State Water Resources Control Board

SUBJECT: CORRECTIVE ACTIONS NECESSARY TO CORRECT ALLEGED WASTE AND UNREASONABLE USE OF WATER BY DOUGLAS AND HEIDI COLE AND MARBLE MOUNTAIN RANCH FROM STANSHAW CREEK IN COUNTY OF SISKIYOU

Photo 7 – Large erosion feature caused by outfall # 2.

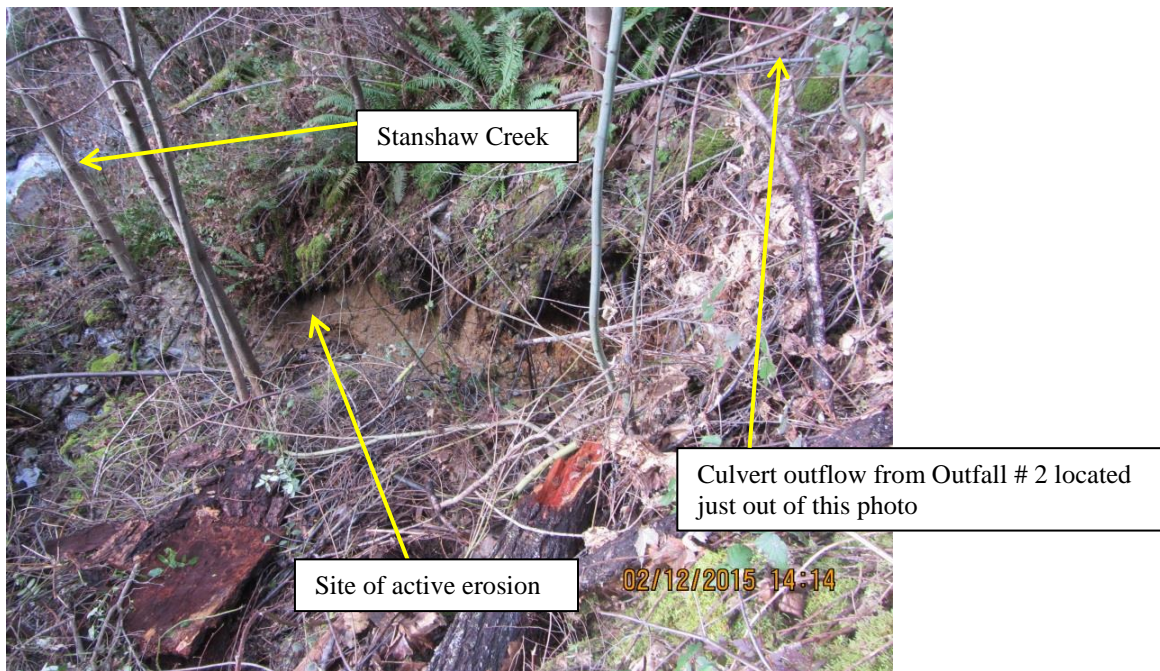
Photo 8 – Area of active cut bank slumping.

Photo 9 – Area of active slumping into MMR Diversion ditch.

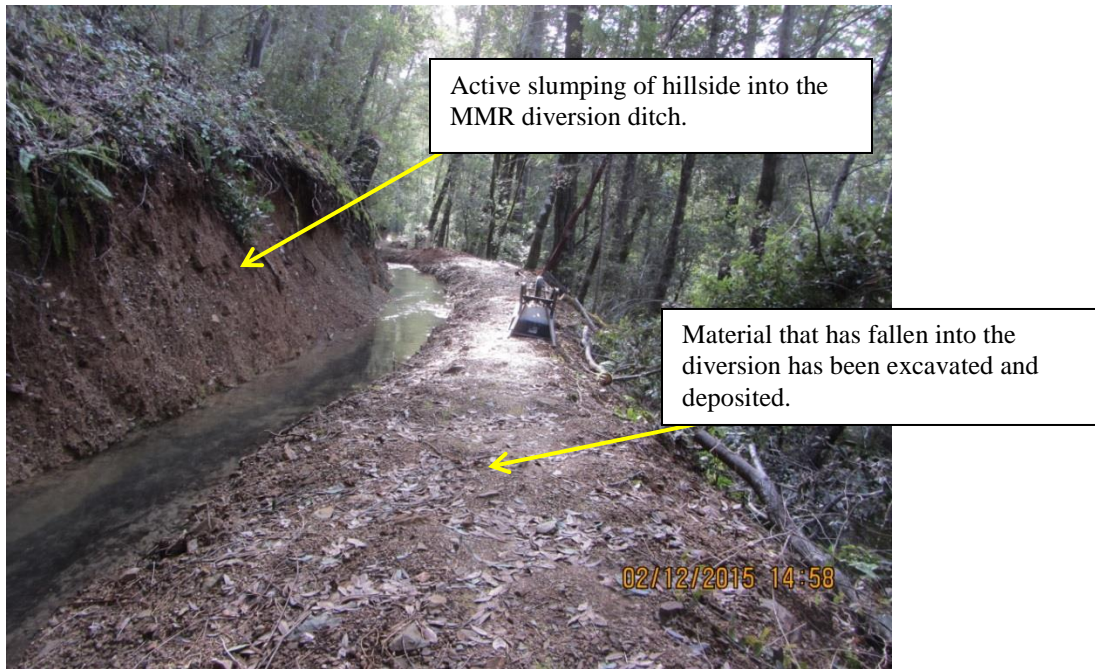
Photo 10 – limited free board space within the ditch.

Image 9- at Point 5, shows the shotgunned 12-inch ditch culvert outlet, diversion ditch and native stream channel flowing under the diversion ditch. (Photos 8442, 8443, 8444, 8445 composite)

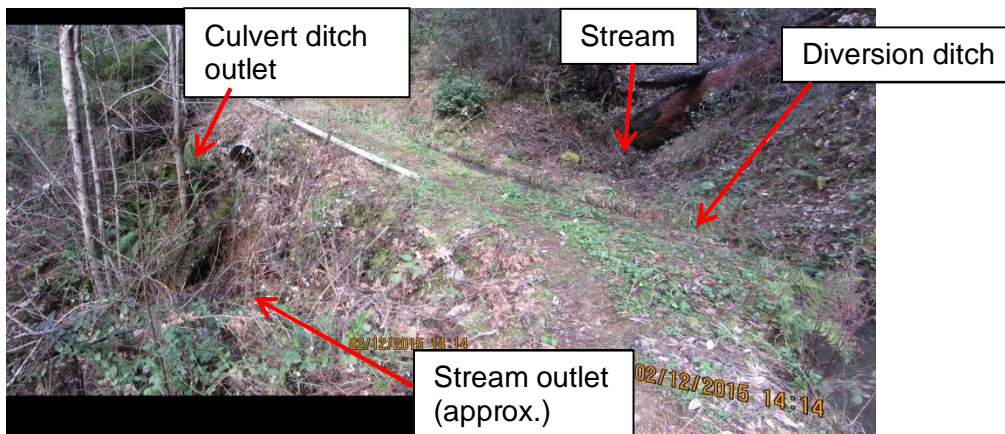
Image 10- shows the unnamed stream channel above Points 4 and 5; the upslope active bankfull stream channel width is approximately 3-4 feet.

For either alternative, the ditch repair or decommissioning plan shall include specifications to restore the affected stream/unnamed tributary that crosses at inspection points 4/5, replant with native vegetation, and to protect streams from any further impacts or discharges associated with the ditch.

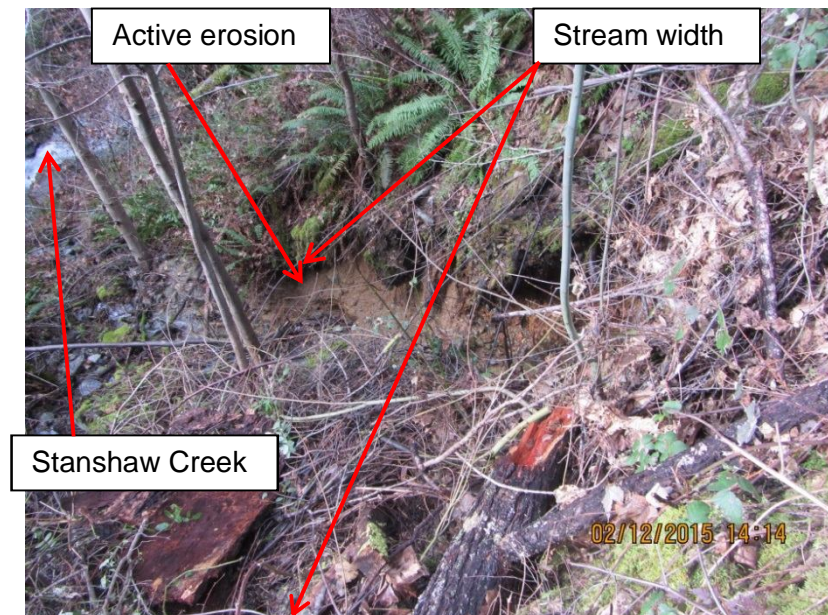
Image 11- shows the unnamed stream channel downstream of Point 5, and the erosion caused by water draining from the shotgunned culvert. Stanshaw Creek can be seen a short distance downslope. I conservatively estimate that this site has delivered 150-300yds³ of sediment and debris to Stanshaw Creek over the life of the Diversion. (Photo 8478)

Image 12- shows Point 6, where the diversion channel is full, leaving no freeboard should it rain or the ditch receive a bank slump upstream. It appears the outboard berm may have failed in this area in the past, and at present is seeping, indicating that a portion of the berm may be saturated. Stanshaw Creek is within 200 feet; any failure here likely results in direct delivery of sediment and erosional debris. The flume section visible in the photo appears to have been installed to remedy previous ditch failures and/or to prevent future failures.

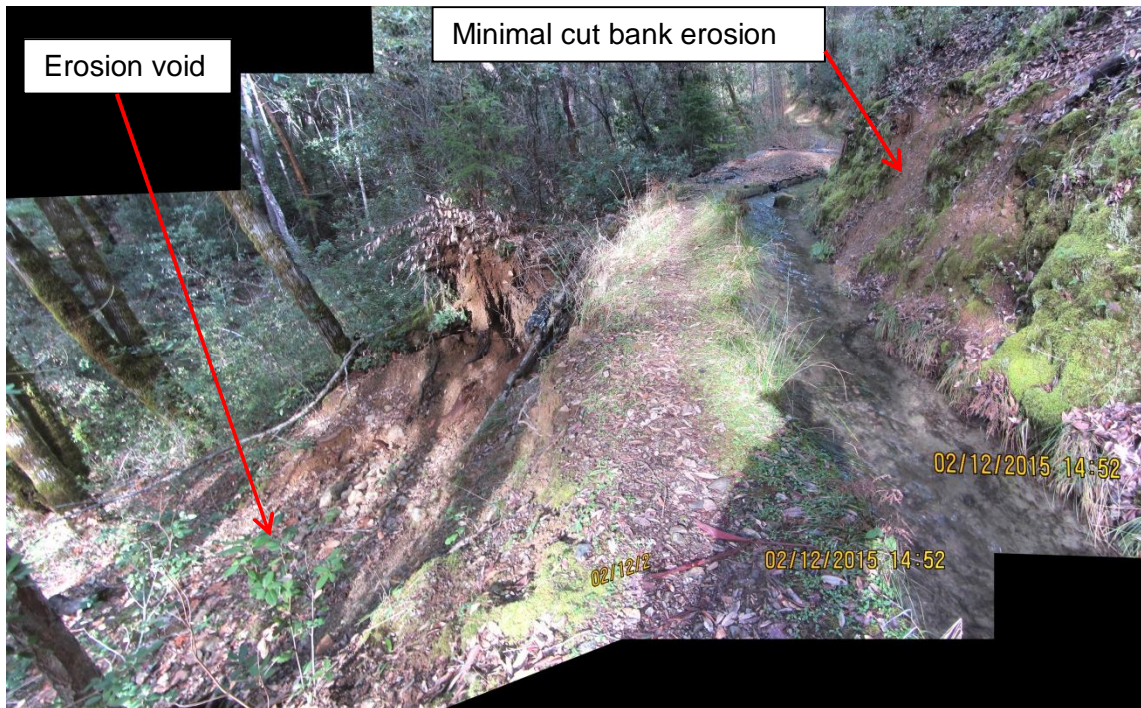
Image 16- Point 10 is an area of concern that includes an erosional channel likely formed by a berm failure and active erosion visible on the cut bank. I observed active cut bank erosion on many of the upper slopes above the diversion ditch and expect that bank slumps have and are contributing significantly to ditch failures. (Photos 8495, 8496, 8497, and 8498 composite image).

Image 17- Point 11 is another 150-200 feet of ditch with a low freeboard and evidence of past failures; this ditch segment leads to a section of ditch subject to a recent bank failure. I observed erosion scars on the lower slopes that are now overgrown with ferns and small shrubs. (Photo 8499)

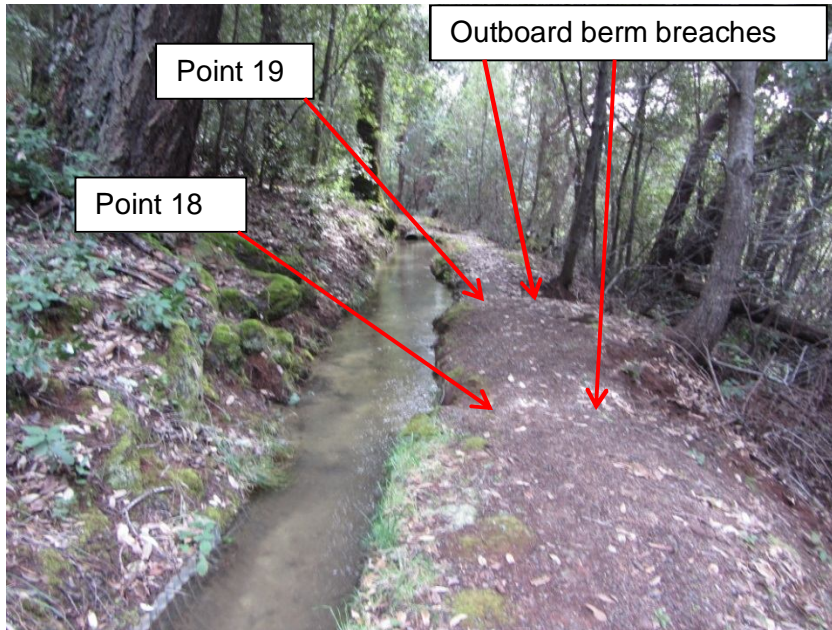
Image 25- shows two locations, points 18 and 19, where the outboard berm has apparently breached in the past, resulting in gully erosion on lower slopes. The failure at Point 19 resulted in the formation of a gully channel for a long distance down the slope, and may have contributed a significant sediment load to the Klamath River and possibly Stanshaw Creek. I did not follow the gully all the way down the slope, but did see an erosion channel from the lower road.

Image 26- Point 20 is the headcut upslope from Irving Creek. This is where tailwater from the Stanshaw Diversion is discharged to an unnamed stream, tributary to Irving Creek. This area is actively eroding. Several trees appear to have fallen recently through erosion of their root masses. I estimate that the headcut erosion has delivered between 1500-2200 yds³ of sediment to the Irving Creek watershed. (Photo 8529)

Regional Water Board staff recommend that an appropriately qualified California licensed professional experienced in Geology and stream restoration evaluate the diversion outfall tributary to Irving Creek and develop a stream restoration plan to restore stream side vegetative and hydrological functions of the tributary, if applicable, and to ensure the long term recovery of the affected streams; and 2) replant slopes and streamside areas with native vegetation to prevent erosion and sediment delivery. The plan shall include provisions to ensure that continued use of this tributary, either for diversion outfall flow or for transport of seasonal flows through the ranch property, does not create new or exacerbate existing erosion.

Figure 8 Example of bypass flow recommendation with assumed 0.3 cfs consumptive use and maximum 3.0 cfs non-consumptive use.

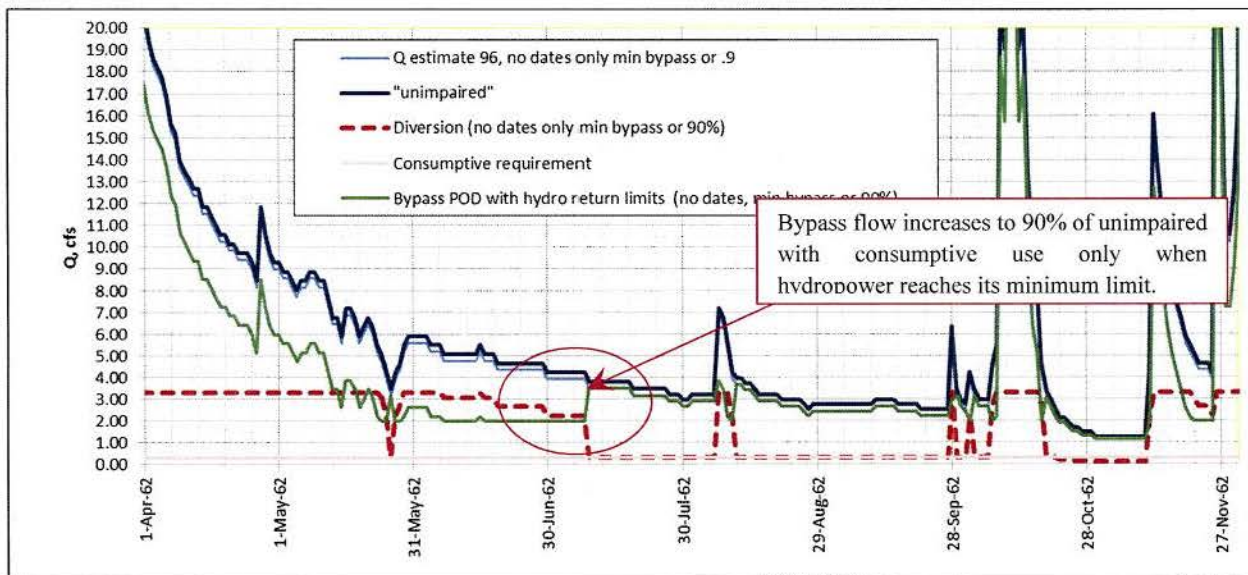
Figure 8 shows an example of the bypass flow recommendation using the Stanshaw Creek daily average stream flow estimates. The figure shows the estimated unimpaired hydrograph for the 1962 recession period and throughout the low flow season, along with the 90% bypass flow after the non-consumptive diversion is returned and the bypass at the POD with a minimum of 2 cfs. Also, shown are the diversions for consumptive and non-consumptive use. Under this bypass flow recommendation, at least 90% of the unimpaired hydrograph is preserved in the anadromous reach. This bypass flow recommendation has a daily variation as the flows naturally recede. If methods to control diversion on a real-time basis cannot be developed, further analysis could be done to establish seasonal diversions that would cover all water year type on a weekly or biweekly or monthly basis to allow manual control of the diversion.
